APPENDIX G: DESIGN INTEGRITY REPORT

Response to Submission

Pitt Street South Over Station Development

SMCSWSPS-URB-OSS-PL-REP-000010

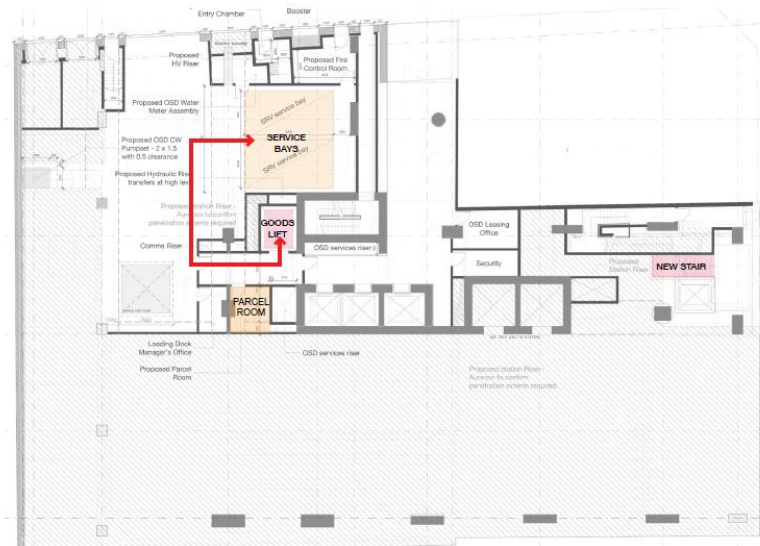
The Panel **requests** that the following be presented at the next meeting:

- Demonstration that the proposed lifts will provide an appropriate level of service to service 227 apartments and other uses.
- Demonstration that the loading dock and service lifts will provide a sufficient level of service.

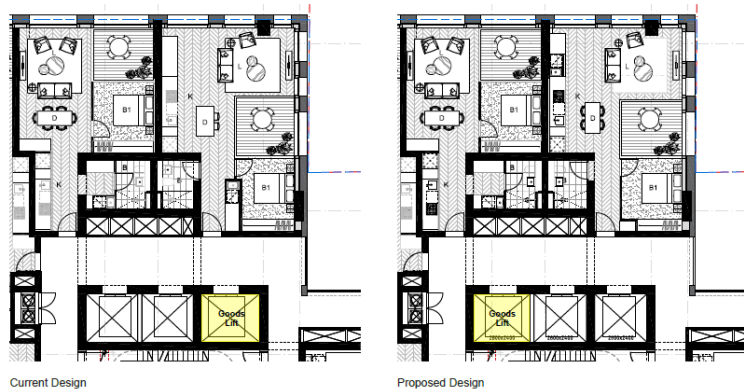
- The Panel supports the proposed lift numbers on the basis of the analysis presented – being 3 passenger and 1 service lift for 227 apartments.
- The Panel raised concerns about the level of service provided by the current arrangement of loading dock and service lift (that requires changing lift at the lobby level). The Panel requested to see alternative configurations bringing the residential service lift closer to the goods lift, or ideally a model that does not require lift change from loading to apartment floors, whilst noting that the client is confident that this model is workable.

- Princeton Apartment Interface – Visual Privacy

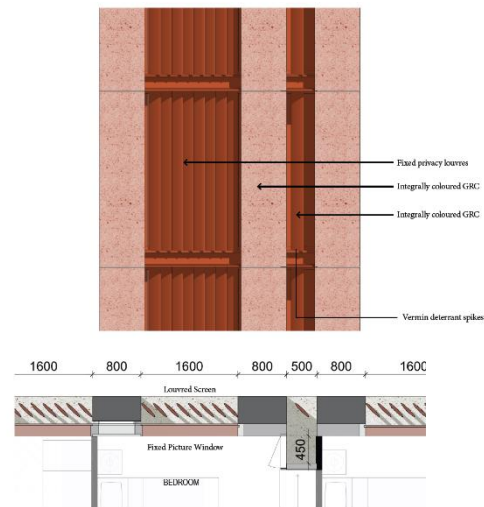
The Panel supports that visual privacy is achieved through the noted vertical louvres to the apartment windows facing the Princeton Apartments.

South façade ventilation

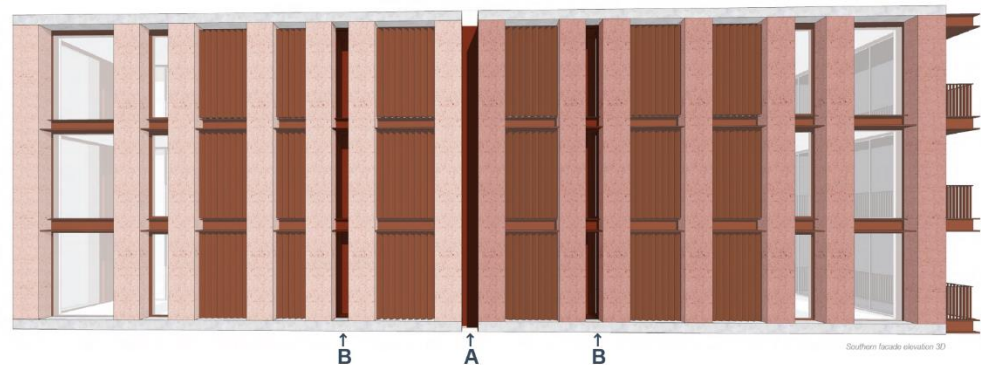
The **Option 2** ventilation strategy was endorsed by the DRP after referral to and consultation with the City of Sydney

- The Panel accepts removal of the vertical blade to the ventilation slot on the south façade (Princeton Apartment interface) noting further development of horizontal ledges to be provided.

Pitt Street Elevation Current and Option 2 and 3

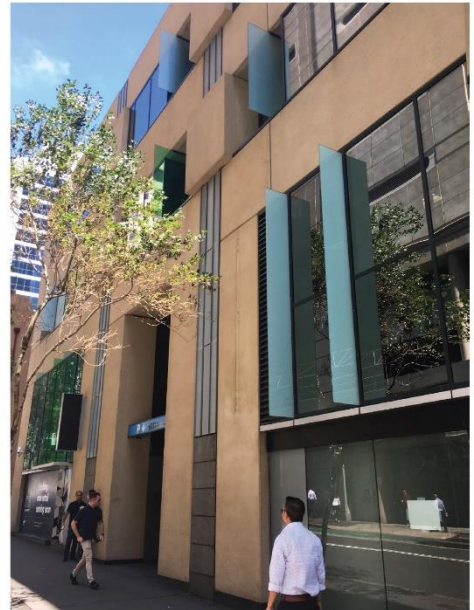
- The Panel note that limited options were developed by the design team to introduce detail into the street level precast panels. The Panel acknowledge that mimicking the brick striations/banding is not a suitable response and recommend further investigation be undertaken to test texture and applied finishes to resolve a finer level of design detail, and that additional larger scale samples are developed and request the DRP are invited to review further proposals. (DIT Item 4.01 response)

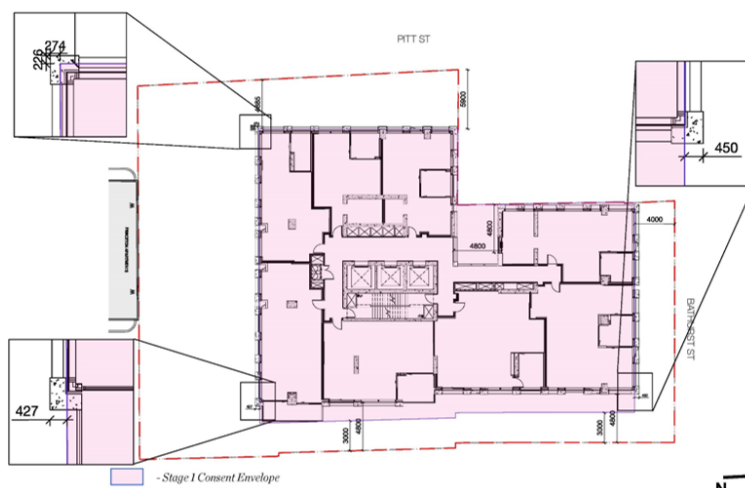
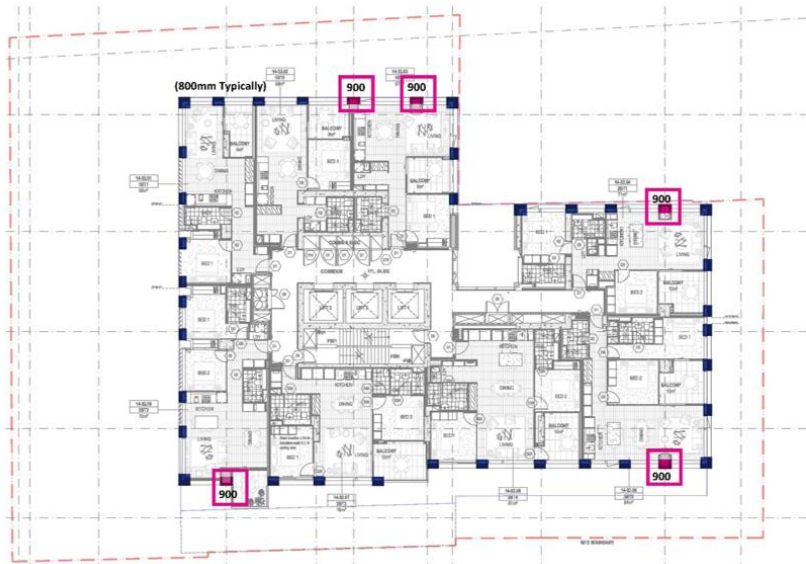
- The adjacent drawing shows the proposed façade projections at the time of SSD DA lodgment which were based on a continuous projection depth of 450mm beyond the glassline.
- South Face:**
Projection varying from 274mm at South West Corner, to 427mm at South East corner, with the variance due to the Southern boundary not being parallel to the building which has been set out to be parallel with Bathurst Street.
- West Face:**
Max projection of 226mm beyond envelope for approx. 50% of frontage length, in an area set back between 4.6m and 5.9m from Pitt Street.
- North Face:**
Max projection of 450mm, in an area set back 4m from Bathurst Street.
- East Face:**
Wholly contained within envelope.

As context, from a DPIE perspective, the encroachments are sensitive in 3 ways:

- 1. South:** Building separation and privacy with Princeton
- 2. West:** Solar impact (if any) on Princeton
- 3. North:** Achievement of quality streetscape on Bathurst Street

- The adjacent drawing shows the current design. The majority of façade projections are 800mm wide x 400mm deep.
- Due to the presence of 4 perimeter columns, these 4 were required to adopt an atypical dimension and were 900mm wide x 400mm deep.
- This resulted in an inconsistency of façade widths we ultimately hoped to refine during detailed design, however the columns cannot decrease in width to achieve 800mm on these elements.

- Therefore, we have increased the width of all the 800mm elements to become 900mm wide, standardizing all elements to the same width.
- This has enabled us to reduce the proposed depth while retaining the same 'visual mass' as described on the following pages.

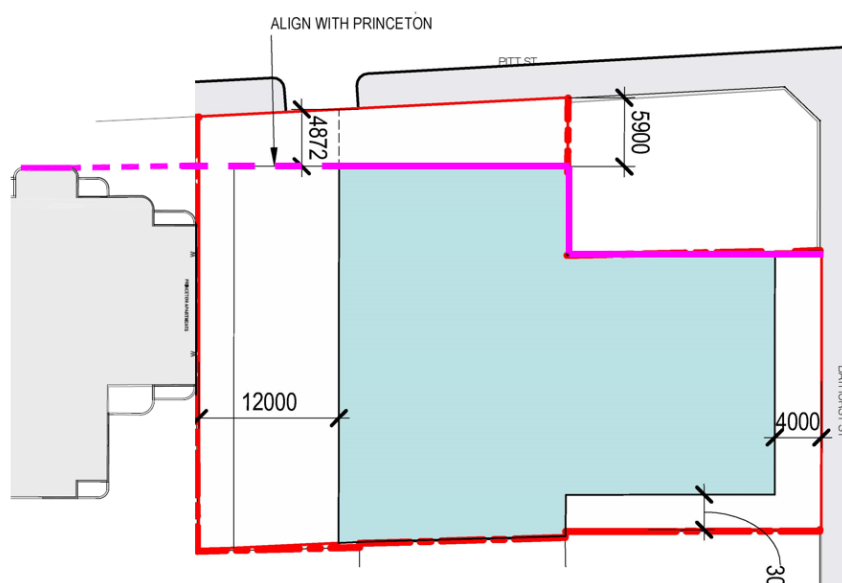
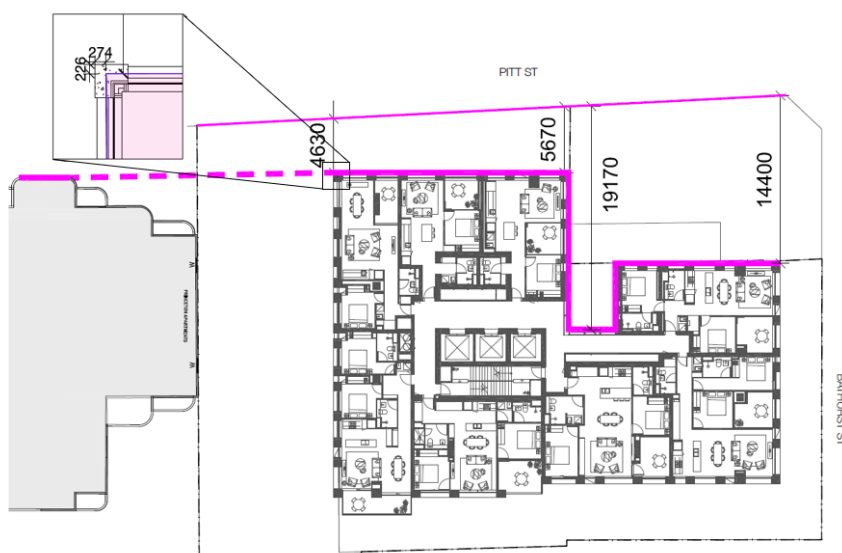
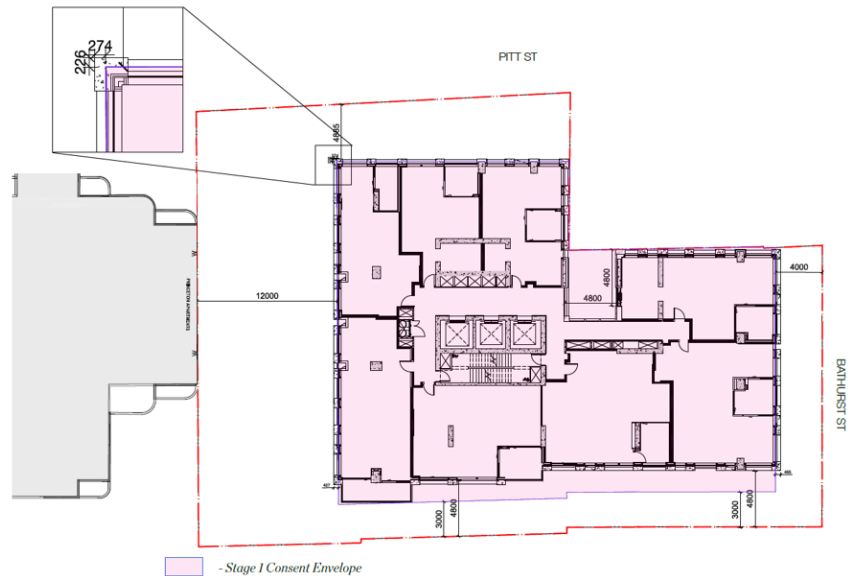
- The adjacent drawing shows the setback to Pitt Street as approved in the Approved Concept Envelope stamped plans.
- The approved setback is varied from the Pitt St Boundary and aligns with the setbacks for Princeton Apartments, as indicated by the note and dimensions on the stamped drawing.
- The purple line (added) shows the variety in setback along this frontage for comparison with our Stage 2 proposal as lodged (overleaf).

- The adjacent drawing shows the setbacks to Pitt Street as proposed in the Stage 2 Application.

The floorplate and glazing line is wholly contained within the approved Pitt Street Setback. Non-habitable architectural façade elements project outside it, as shown in the adjacent detail. The result is a *minimum* setback to 4.63m from the approved 4.872m.

- The resultant Pitt St Setback :
 - a) Is varied and aligns with Princeton Apartments,
 - b) Is more varied / articulated than the approved concept envelope due to the inclusion of a vertical articulation 'slot' above the Edinburgh Castle Hotel, increasing the setback from 14m to 19m in the midpoint of the site.
 - c) Is fully complying with the approved envelope with the minor exception of the non habitable GRC elements which project a maximum of 226mm beyond.

- As mentioned on the previous page, these non external non-habitable architectural shading elements project outside of the concept envelope by 226mm on the Pitt Street frontage for the portion between Princeton Apartments and the Edinburgh Castle Hotel
- The point at which these minor projections fall outside of the envelope on the South West corner results in 9 apartments within Princeton Apartments losing an average of 3 minutes of solar access between 9am – 3pm on the 21st June, when compared with the approved concept envelope.
